Subdivision approval to create one (1) legal lot of record from two (2) existing legal lots of record.

WESTERN DRIVE COMMERCIAL PARK SUBDIVISION, RESUBDIVISION OF LOTS 1 & 2

APPLICATION NUMBER ______ 2 DATE ____ July 20, 2023

DETAIL SITE PLAN

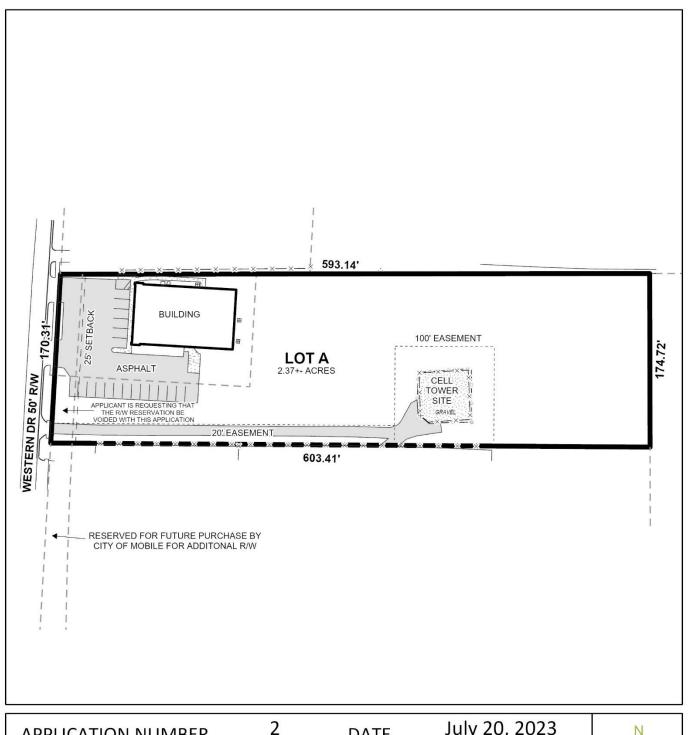
The site has frontage on Western Drive, a minor street with curb and gutter requiring a 50-foot right-of-way at this location. The preliminary plat illustrates a compliant right-of-way for Western Drive; therefore, no additional dedication should be required.

There is a note on the plat stating "Reserved for Future Purchase by The City of Mobile for Additional R/W." As additional right-of-way is not needed, this notation should be deleted from the Final Plat.

The lot, as proposed, exceeds the maximum depth of 3.5 times the width of the lot. If approved, a waiver of Section 6.C.(b)3. of the Subdivision Regulations will be required, and may be appropriate considering previous subdivision of the site have been approved with a similar configuration.

The preliminary plat submitted illustrates a 25-foot building setback line along Western Drive, which meets the minimum setback requirements of Section 64-2-21.E. of the Unified Development Code. This should be retained on the Final Plat, if approved.

The lot exceeds the minimum size requirements of the Subdivision Regulations for lots served by public water and sanitary sewer, and is labeled with its size in square feet and acres. This information should be retained on the Final Plat, if approved.

A 20-foot access and utility easement is illustrated along a portion of the South property line. All easements must be illustrated and a note should be placed on the Final Plat stating that no structure shall be constructed in any easement without permission of the easement holder, if approved.

- 1. Retention of the 50-foot right-of-way width along Western Drive as depicted on the preliminary plat;
- 2. Revision of the plat to remove the reservation of right-of-way notation;
- 3. Retention of the lot size in both square feet and acres, or the furnishing of a table on the Final Plat providing the same information;
- 4. Retention of setbacks as illustrated on the preliminary plat;
- 5. Placement of a note on the Final Plat stating that no structure shall be constructed in any easement without permission of the easement holder;
- 6. Compliance with all Engineering comments noted in this staff report;
- 7. Placement of a note on the Final Plat stating all Traffic Engineering comments noted in this staff report;
- 8. Compliance with all Urban Forestry comments noted in this staff report; and,
- 9. Compliance with all Fire Department comments noted in this staff report.
